# ALERT SERVICE BULLETIN

NO. 407-09-91  
DATE DEC 17, 2009  
PAGE 1 of 6

**MODEL AFFECTED:** 407

**SUBJECT:** HOSE ASSEMBLY P/N 70-079H100F210, ONE TIME INSPECTION OF.

Figure 1 – Hose Identification Tag

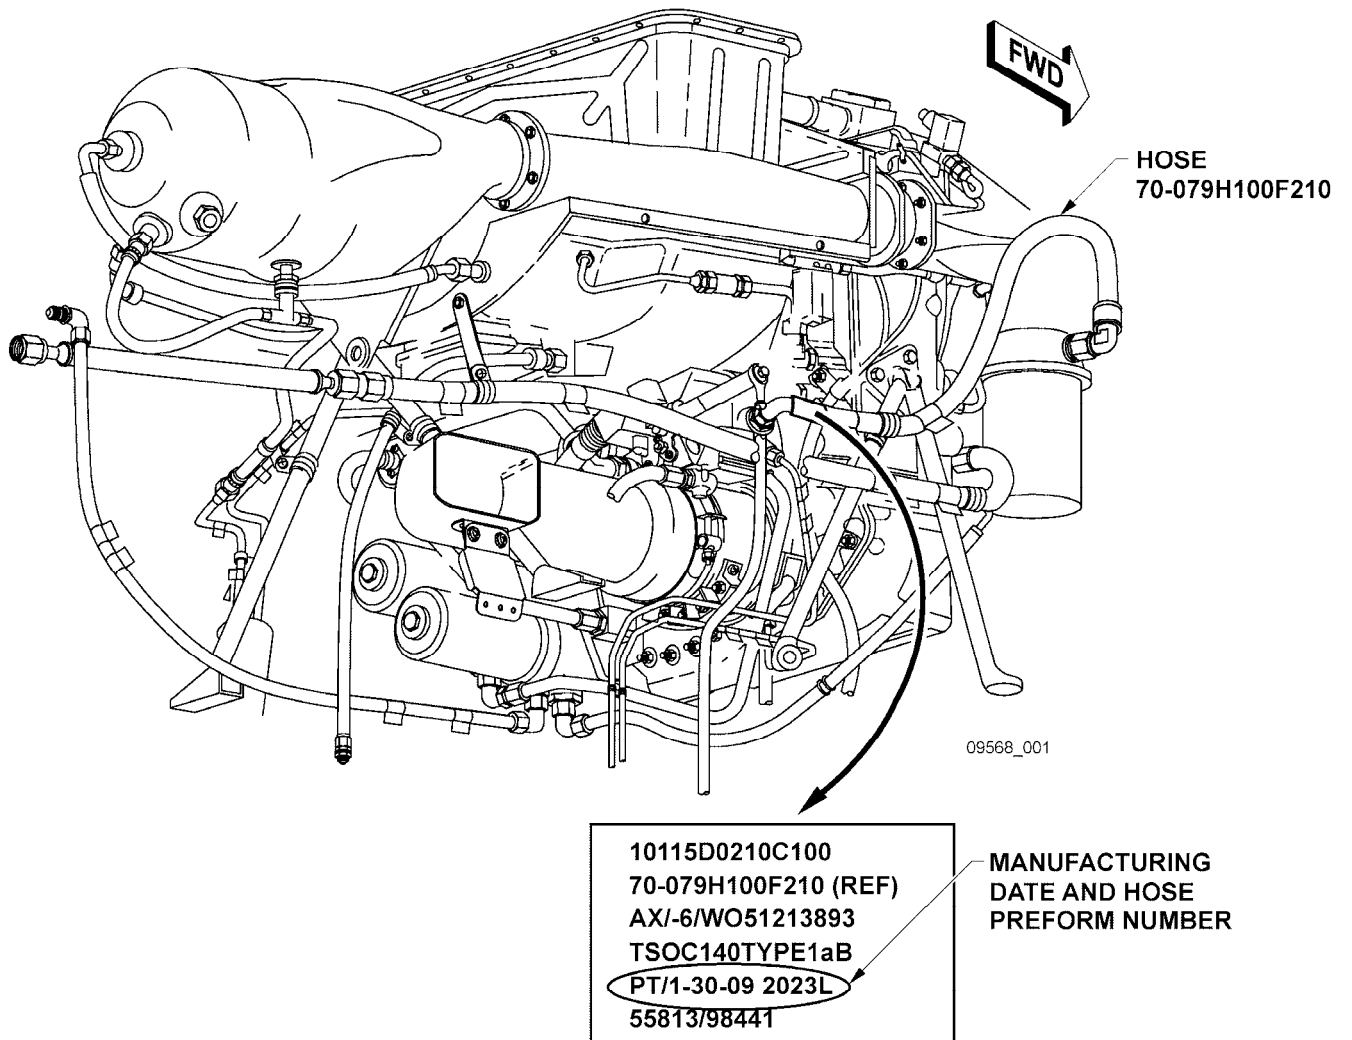
1. Gain access to the affected hose (see Figure 1) and locate hose identification tag.

The manufacturing date and hose preform number are located on line #5 of the identification tag.

2. On the hose identification tag locate the manufacturing date and preform number of the hose assembly. Only hoses identified with date codes and preform number shown in table 1 are affected by this bulletin.
3. If an affected hose is found, start the aircraft and perform a leak test, paying particular attention for leaks at this hose.

2. Remove and discard the HMU union and packing.
3. Install packing on new union and install, torque to 200 to 250 in/lbs.
4. Install new hose assy, torque to 100 to 250 in/lbs.
5. Start the aircraft and perform a leak test.
6. Submit an MMIR to the Bell Warranty Department (as per the warranty section of this bulletin).
7. Annotate aircraft records to reflect compliance with PART II of this bulletin.
